In the Matter of: ADVISORY COMMITTEE ON REACTOR SAFEGUARDS
METAL COMPONENTS WORKING GROUP

DATE: September 30, 1982 PAGES: 1 - 268
AT: Washington, D. C.

PRESSURIZED THERMAL SHOCK
PRESENTATION TO
ACRS METAL COMPONENT SUBCOMMITTEE

FIGURE 2-12

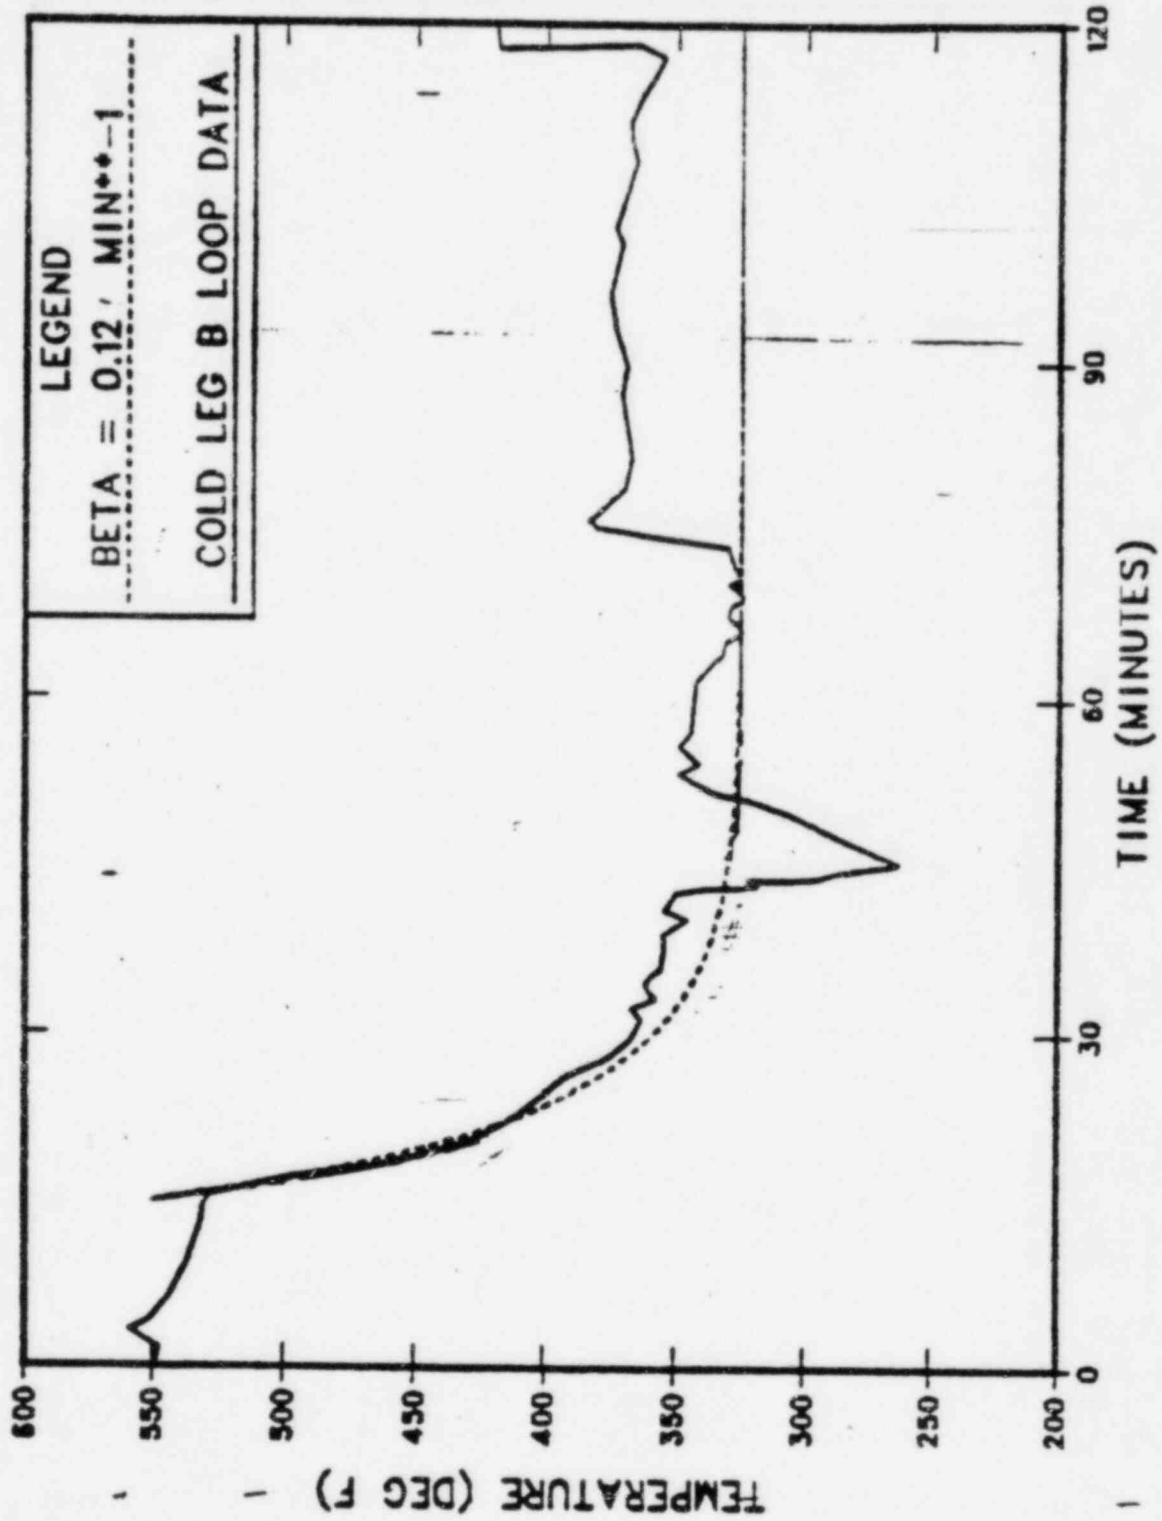
15 MR. ZUDANS: No, I don't think so. The
16 question was very simple and straight. Is this the
17 lowest possible temperature in the downcomer or not?
18 And if you can't make that statement --

23 MR. HANAUER: The answer is no, this is not
24 the lowest possible temperature, because of the unknown
25 degree of stratification at the point of measurement.

FIGURE 2-14

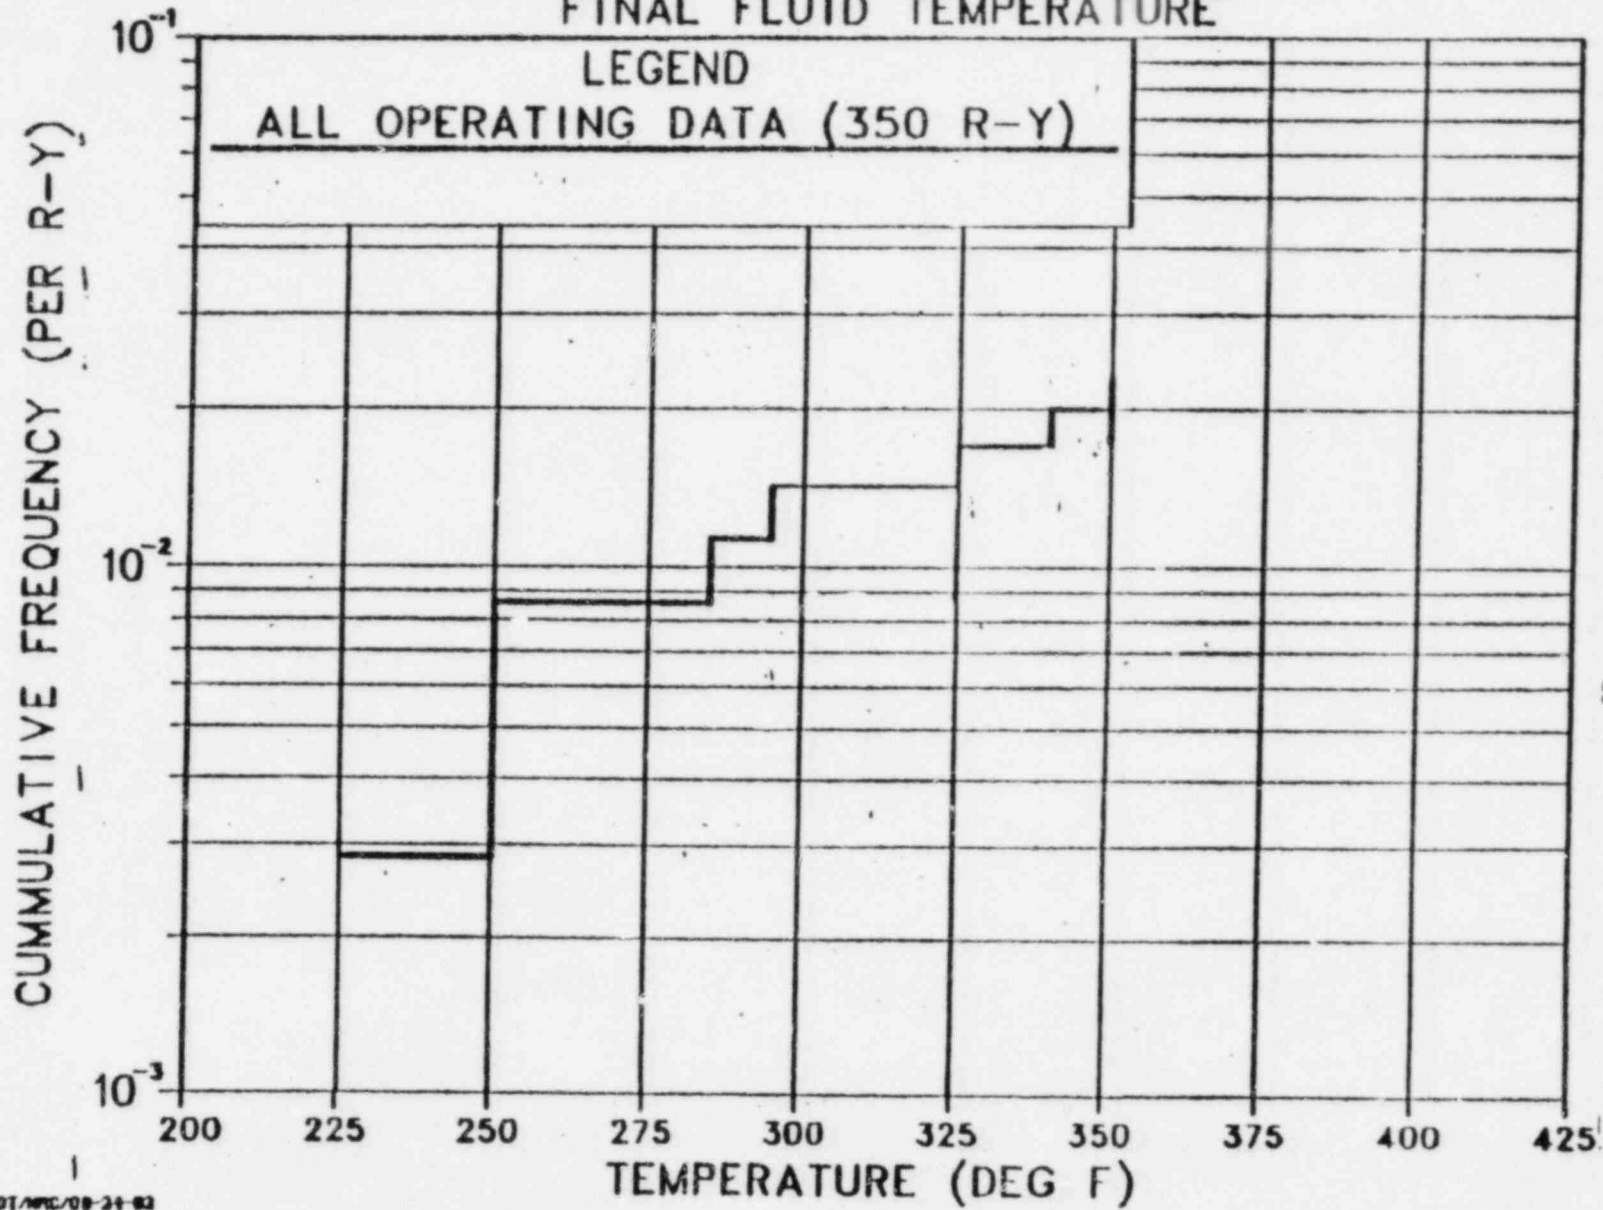
2 MR. BENDER: Well, there is a little bit of a
3 contradiction in the discussion. It doesn't represent
4 today's plants. I fully agree with that. And because
5 it doesn't, trying to present a frequency relationship
6 of the sort you have there distorts the problem
7 probably.

9 MR. BENDER: And distorts it in what may make
10 the public safety question seem worse than it really is.

21 There is no way in my opinion that this could
22 be a worst case. Since we have had corrective measures,
23 it is my opinion that this curve is somewhat worse than
24 plants today. How much worse, well, if we do our PRA
25 very well, and if it has the kind of discrimination

1 which would show up such differences, then the PRA curve
2 would lie below this one, and if that were the only
3 reason for the difference, you would say that that shows
4 the benefit of what we have done in backfitting, or you
5 could wait ten years and draw -- or 350 more reactor
6 years and see if the curve looked any different.

7 Well, we don't have time for that. The
8 current answer, since we can't do it with experience,
9 has to be in the probabilistic evaluation which should
10 be done on the plants as they are now with the backfits
11 in, and those plants that do plant specific evaluations
12 need to do that, and it will show for a variety of
13 reasons that present day plants are better than this,
14 and that will be one of the reasons.

EXAMPLE OF NRC PRESCRIPTION FOR RT_{NDT} (FOR ASSUMED
RT_{NDT} (o) OF 0°F)

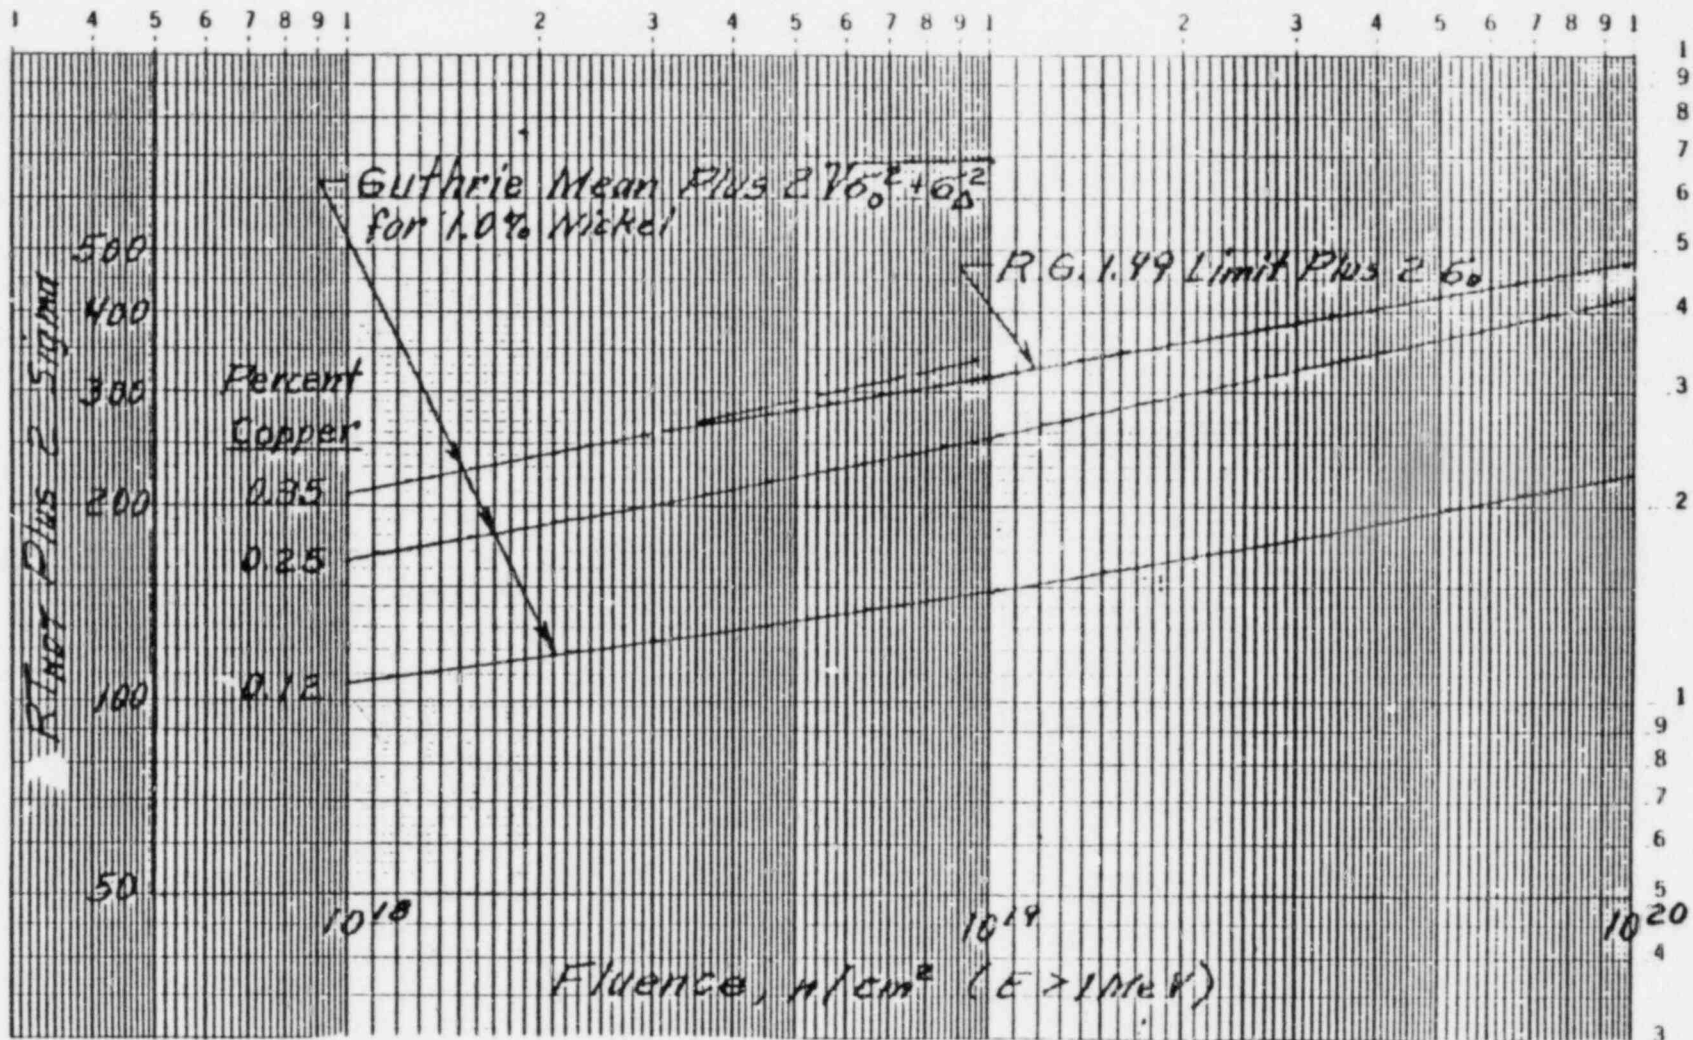
14 MR. WECHSLER: Yes. My question relates to
15 the statement that Steve Hanauer made that the Guthrie
16 fit, the Guthrie equation shows very high predicted
17 delta T or delta RT's NDT and for that reason instead of
18 using the Guthrie fit for the higher fluences, they
19 chose to use the Reg. Guide 1.99, and so I asked, what
20 is the rationale for having done that. I understood
21 Neal Randall to say that the reason was, as you can see
22 in this figure, E-17 in Appendix E, you can see that the
23 plus two sigma line is above all the residual values in
24 that plot, not just those that pertain to fluences above
25 10^{19} , and so I still remain uncertain as to the

1 MR. WECHSLER: I see, so you are essentially
2 saying that above 10^{19th} in Figure H-17, there are
3 more points lying above the zero line than lie below
4 it. In other words, your formula overpredicts based on
5 the actual data for fluences above 10^{19th}.

19 MR. ZUDANS: There still remains this question
20 that I asked, namely, why the population wasn't split up
21 into two pieces at that point.

11 MR. GUTHRIE: I was not intimately involved in
12 drawing this broken part of the curve there, where the
13 1.99 went in. But if you look at this figure that we
14 have been referring to for the last couple of minutes,
15 if you became sympathetic to the owners and wanted to
16 give them as much as you could and still maintain
17 safety, you could draw a slightly tilted line in the
18 upper righthand part of the figure and still bound the
19 data that is plotted on this graph, and this does give
20 -- well, it doesn't penalize the owners as much as they
21 would be penalized if you used the plus two sigma lines.
